JUL 23 2007

has permission to Construct a building for the storage and handling of universal wastes

RE: City of Portland, Maine
Supplemental Submission, Site Plan Application
Riverside Transfer Station
Portland, Maine
St.Germain File No.: 2844.1

**Re: Site Plan Review: 910 Riverside Street, Riverside Transfer Station
Application 2005-0246**

UNIVERSAL WASTE BUILDING	
SOLID WASTE TRANSFER	
PORTLAND	
SHEET TITLE: NORTH - SOUTH ELEVATIONS	
THIS DRAWING IS ISSUED: <input checked="" type="checkbox"/> Submitted For Permit	
DRN BY: BWN/RAW	DATE: 3/14/2007
CHD BY: BWM	SCALE: AS NOTED

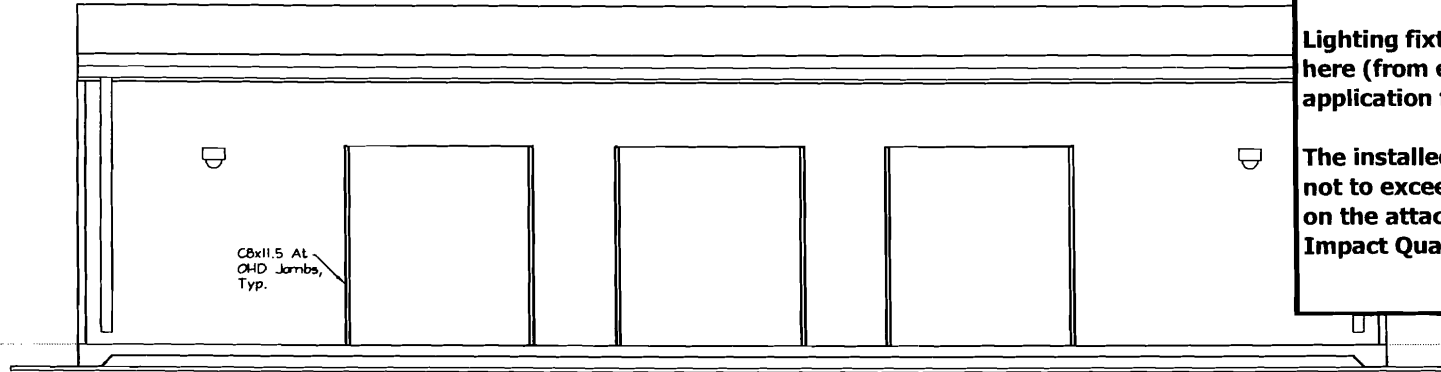
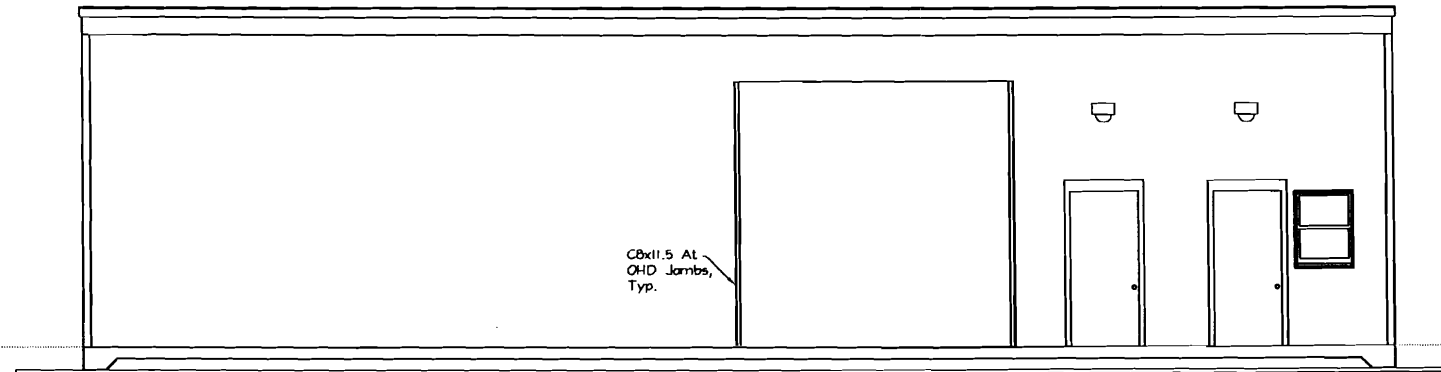
Lighting fixtures will differ from those shown here (from elevations submitted with the application for building permit in May 2007).

The installed fixtures will be cut-off fixtures, not to exceed 250 watts such as those shown on the attached specification for Lumark IP Impact Quarter Sphere fixtures.

#2005-0246 with Cond 3 met
based on this
amendment as approved
7.17.07 m

UNIVERSAL WASTE BUILDING		EAST - WEST ELEVATIONS		PKY	DWG
SOLID WASTE TRANSFER		Submitted For Permit		3/14/2007	AS NOTED
PORTLAND	THIS DRAWING IS ISSUED:	DATE:	SCALE:		
SHEET TITLE:	<input checked="" type="checkbox"/> Submitted For Permit				
	DWN BY: BWM/RAW				
	CHKD BY: BWM

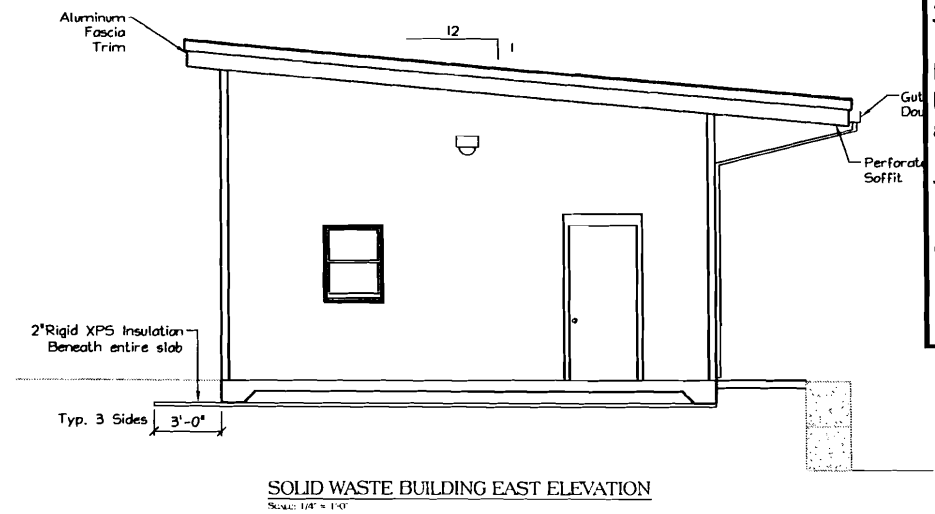
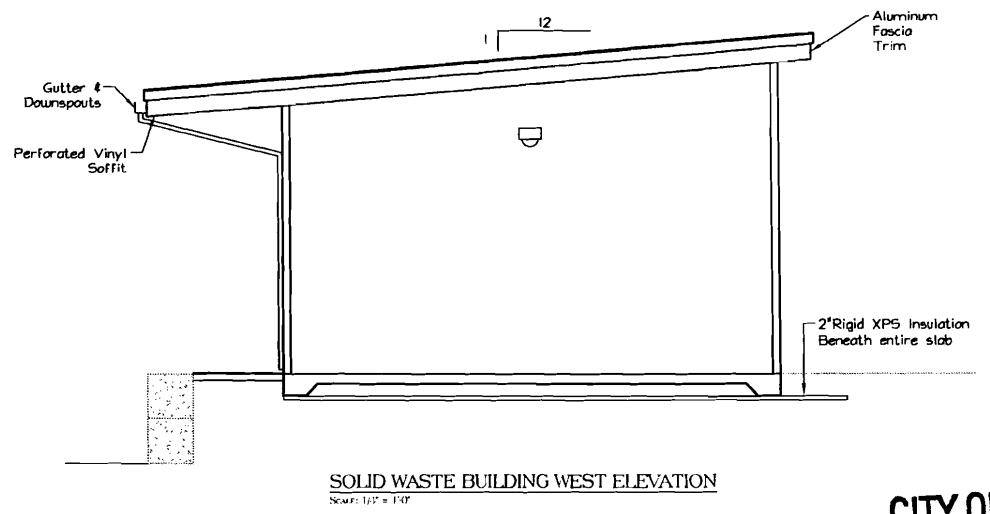
Lighting fixtures will differ from those shown here (from elevations submitted with the application for building permit in May 2007).

The installed fixtures will be cut-off fixtures, not to exceed 250 watts such as those shown on the attached specification for Lumark IP Impact Quarter Sphere fixtures.

Subject to Dept. Conditions
Date of Approval: 02-07-06 # 2005-0246
with cond. # 3 being met based
on this amendment which was approved
7.17.07
